February 28, 2022

RE: WRG-21-05 Windham Oaks Gangway Completeness Response

SUBJECT: WRG-21-05 Application requesting a Willamette River Greenway Permit and Flood Management Area Permit that would allow for a new gangway on 2125 Windam Oaks Ct where there is also joint access by 2115 Windam Oaks

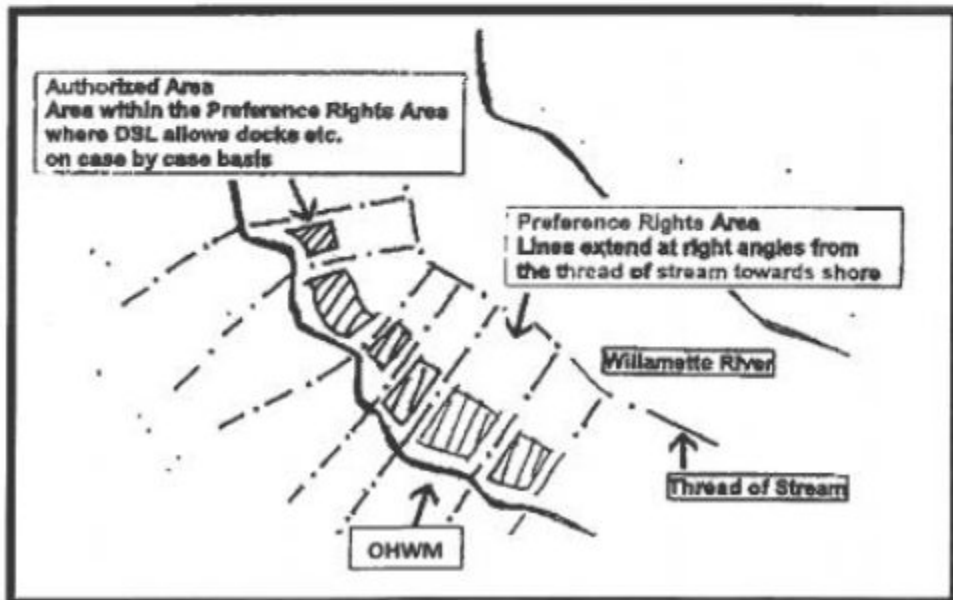
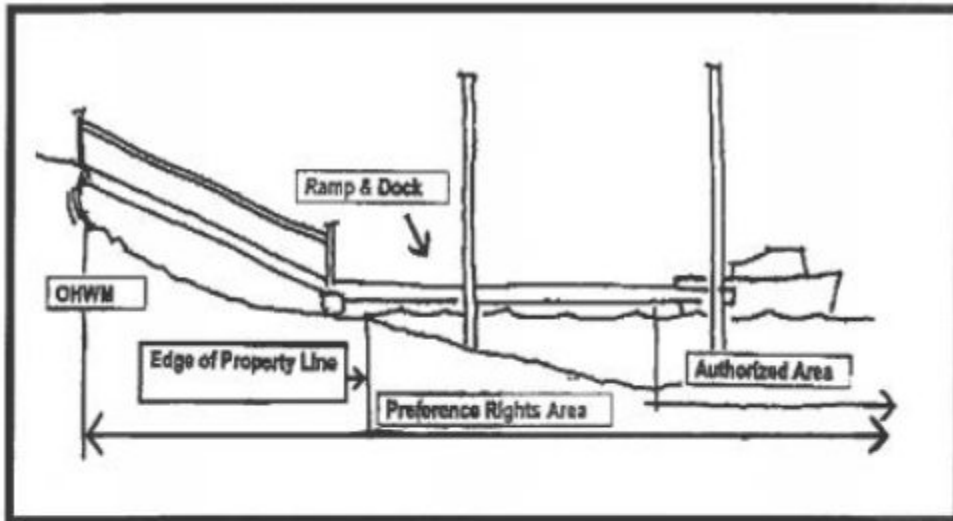
- a. The Plan sheets do not show the preference rights area or authorized area for the water surface structure. Indicate on the plans where the preference rights/authorized rights are located.
- b. It appears that a portion of the proposed gangway will be in the preference rights area; therefore, you will need to include a map that has been approved or acknowledged by DSL.

Response: No preference rights area pertains to the existing dock and a preference rights area map was never required due to the size of the existing and proposed water-dependent structures. As indicated by the email included as Attachment F, sent by Justin Russell- the Department of State Lands Proprietary Coordinator, the proposed gangway is authorized within the existing dock registration and does not require further authorization.

**PRELIMINARY PILE CUT-OFF
 ELEVATION, GANGWAY
 PROFILE, & SITE PLAN**

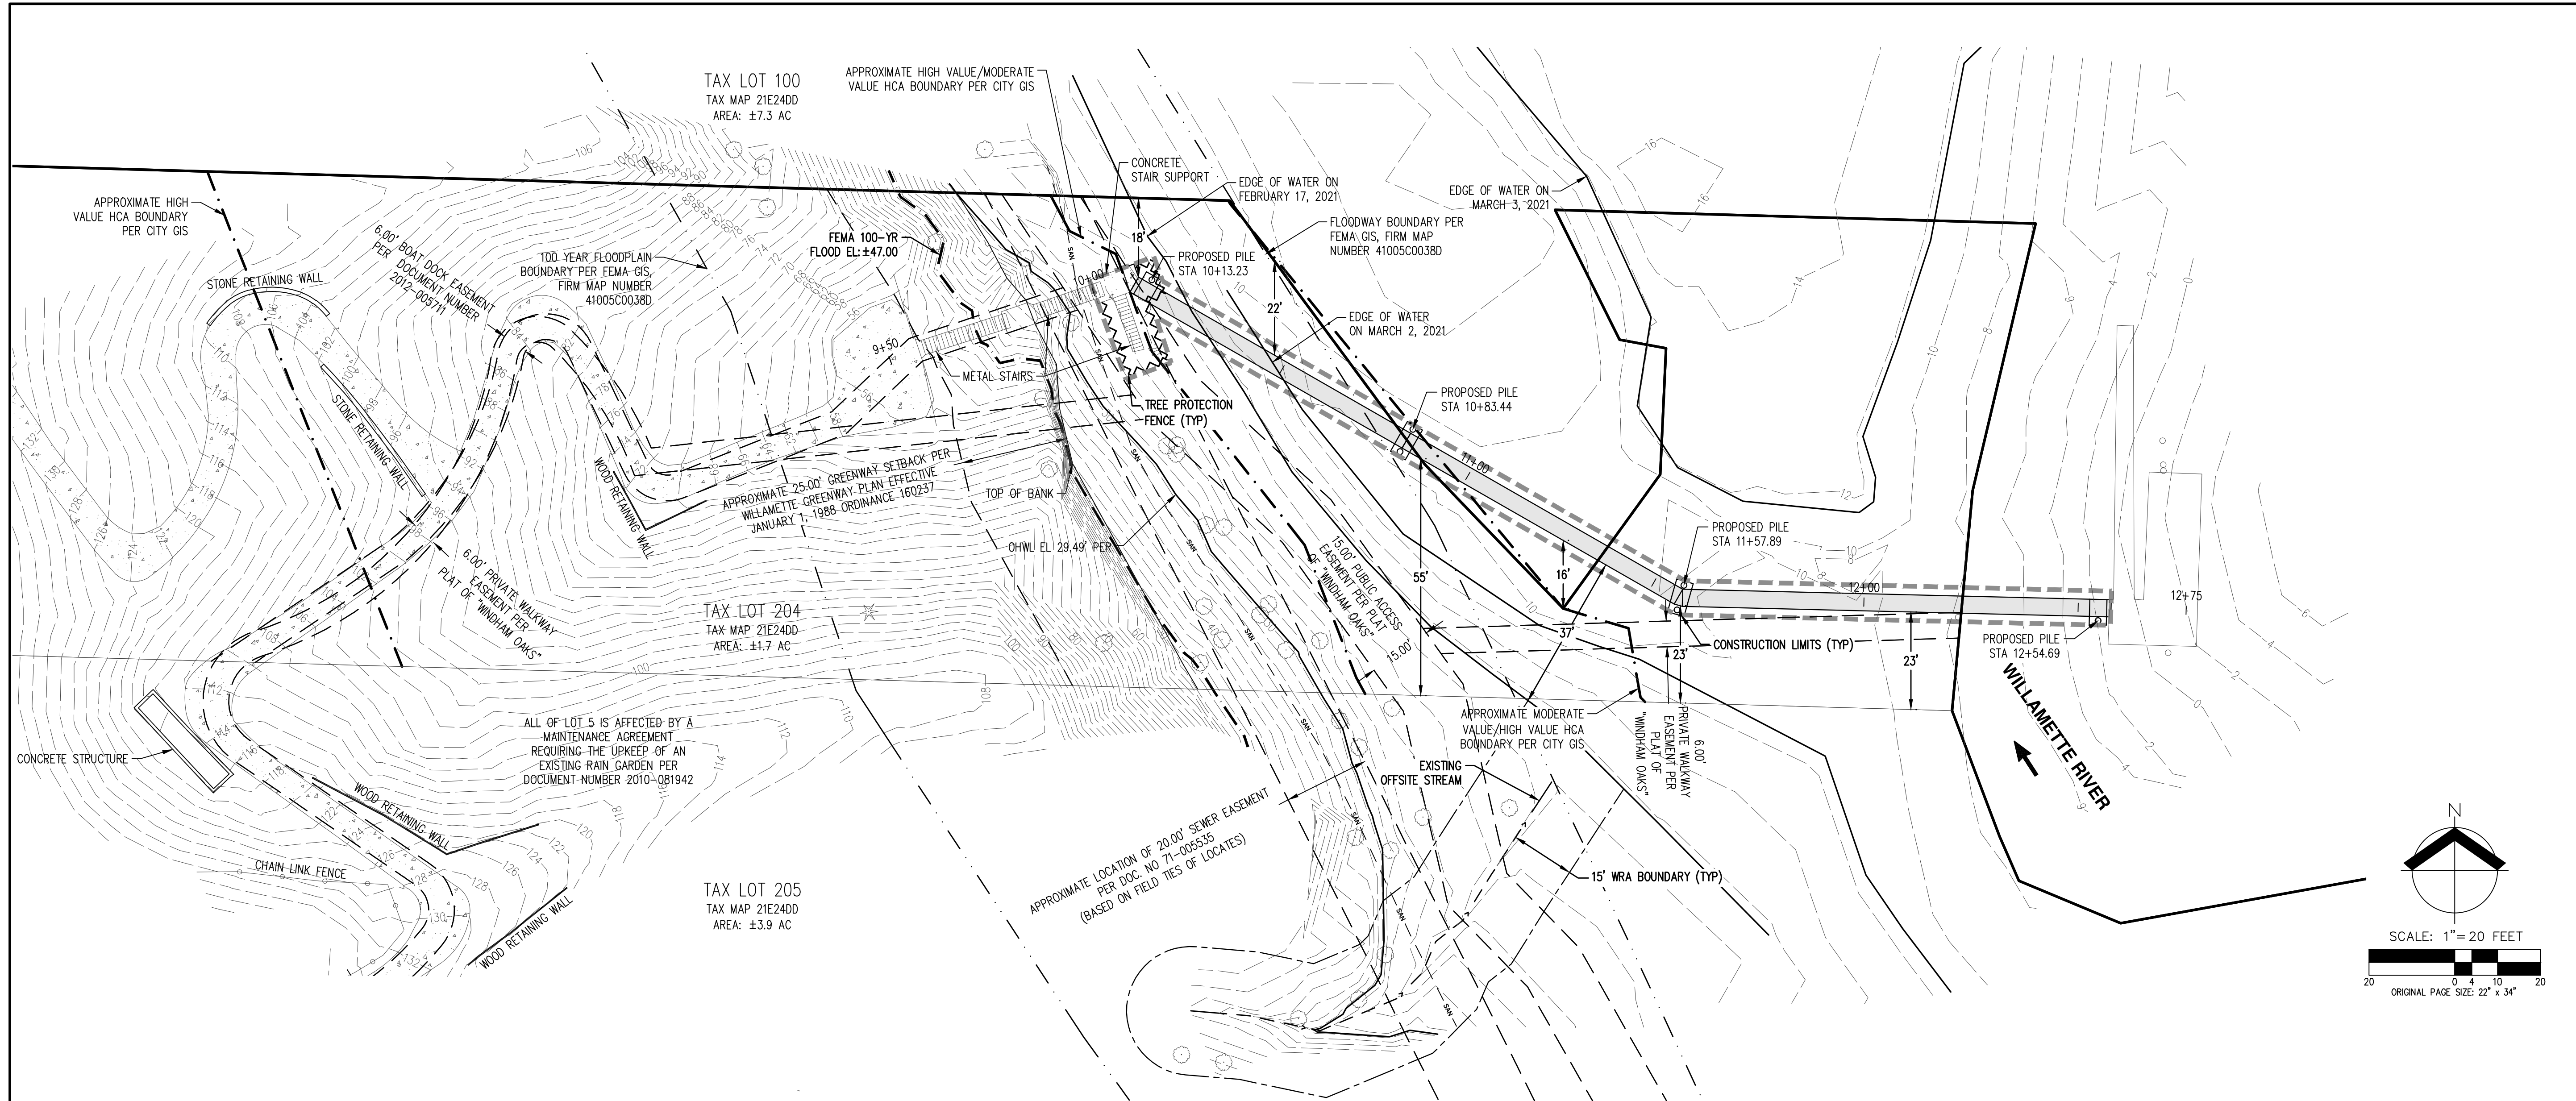
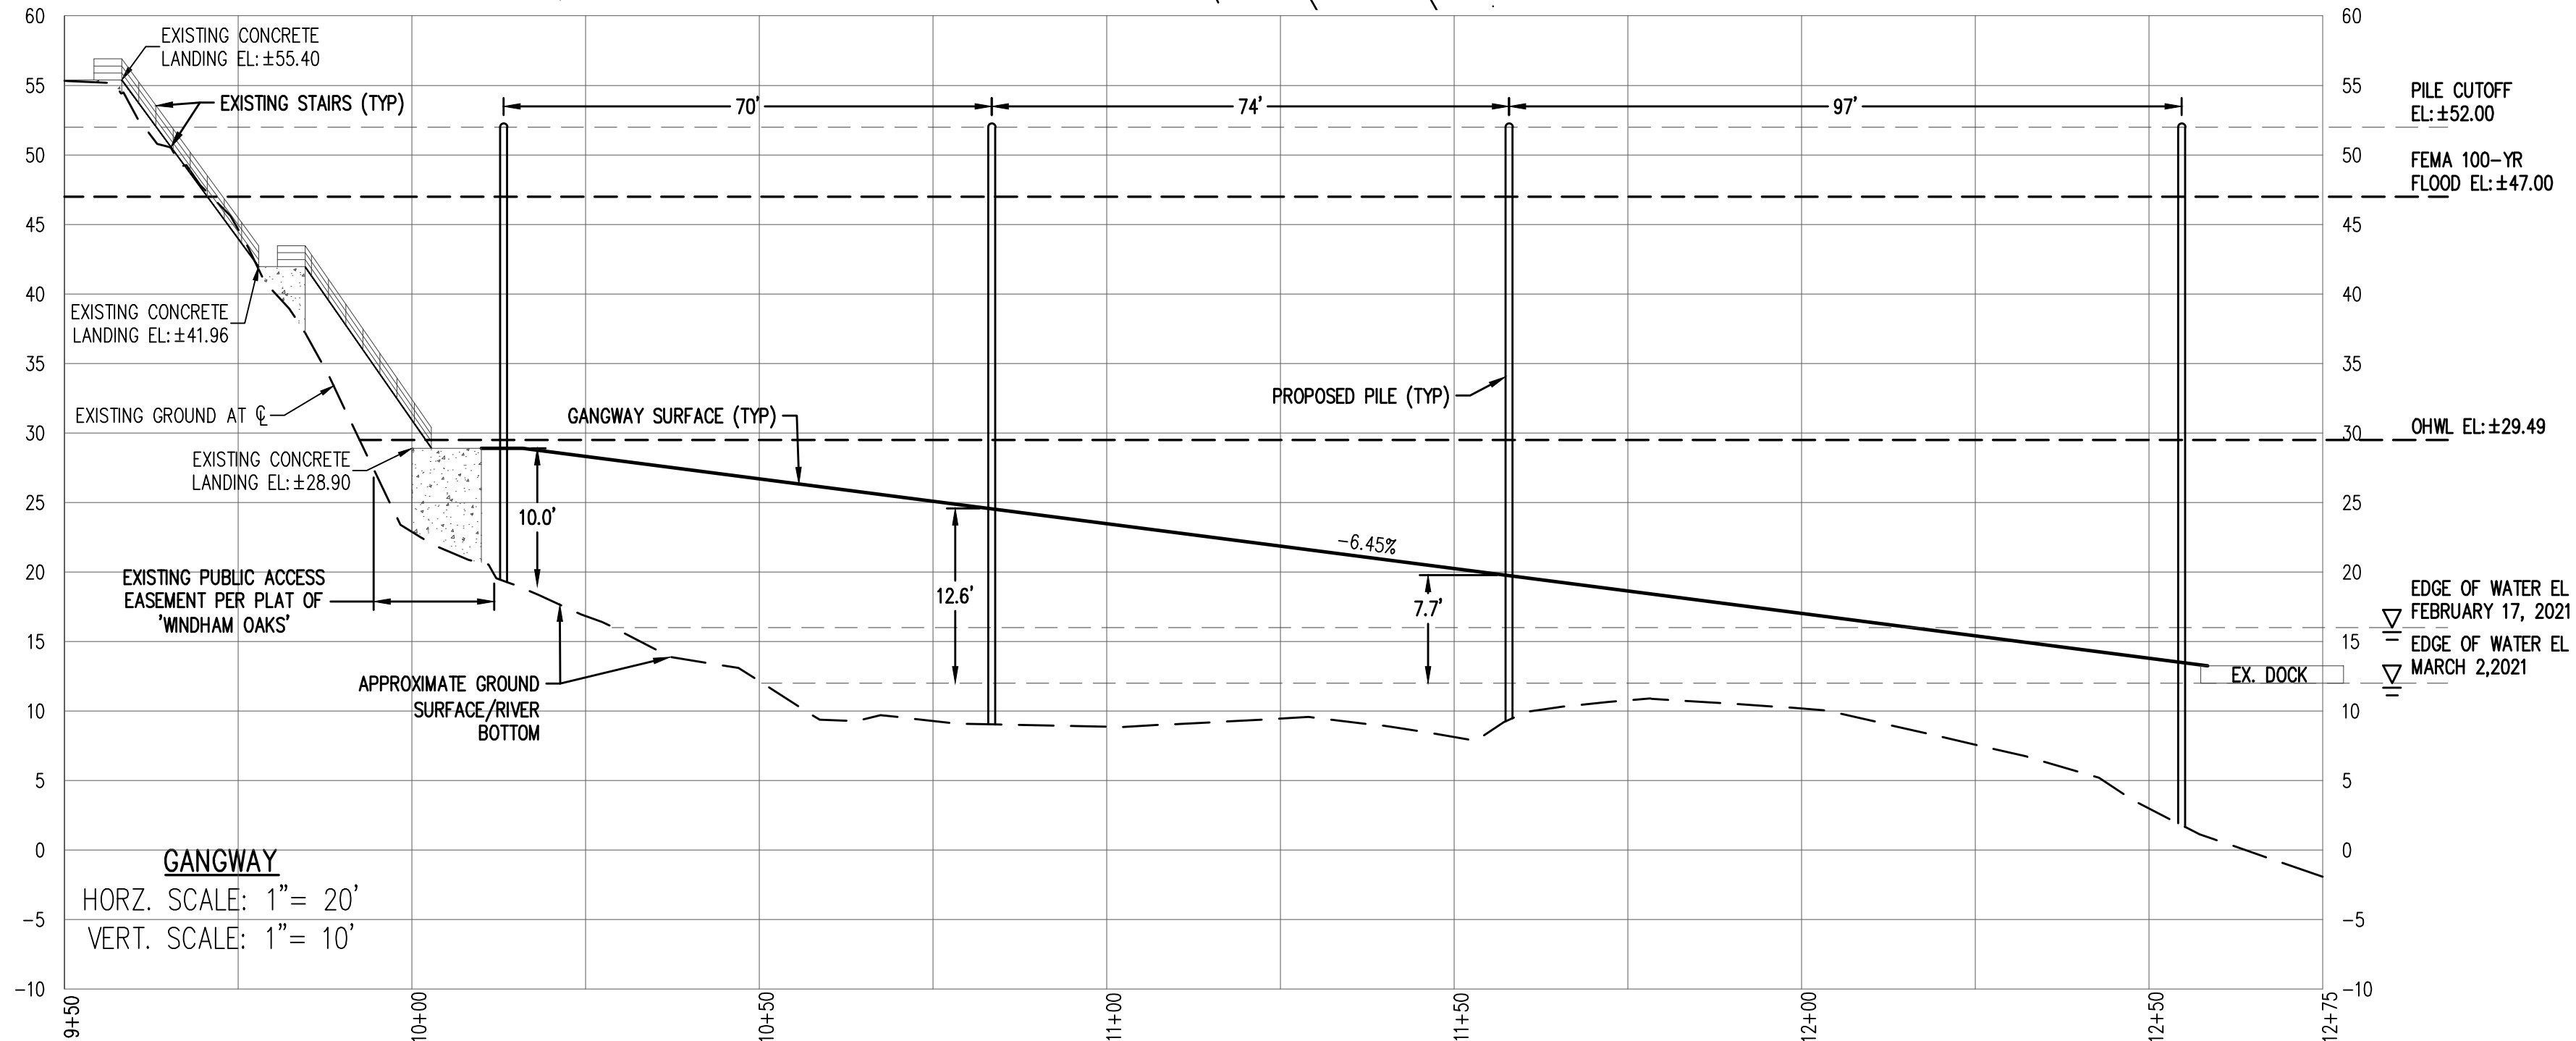
There is reference to Sheet P04, but there is no cut and fill shown on the plans. Please label the areas for cut and fill on the plans. Is there an equal amount of both cut and fill?

There is reference to Sheet P04, but there is no cut and fill shown on the plans. Please label the areas for cut and fill on the plans. Is there an equal amount of both cut and fill?

Response: The proposal does not include areas of cut and fill. A letter, signed by a registered civil engineer, was included in the original application materials attesting to the fact that the project will not impact the Willamette River Floodway. The engineer's letter is included with this response package as Attachment E.
